# Product Change Notification

**Change Notification #:** 110098 - 00  
**Change Title:** DG43RK, PCN 110098-00, Product Design, BIOS update and adding alternate component to improve manufacturability  
**Date of Publication:** June 10, 2010

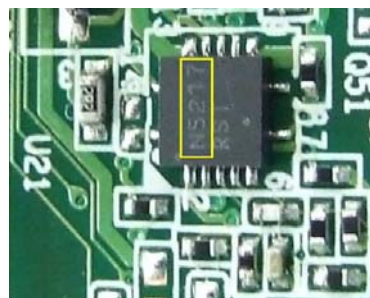
1. BIOS update to RKG4310H.86A.0082. To access release notes or a copy of the BIOS for evaluation, go to <http://downloadcenter.intel.com>
2. Added a second source vendor for the component at location U21 to ensure adequate supply. Body markings of both components are shown below:

Component marking: **TI** xxx

Component marking: **N**xxxx
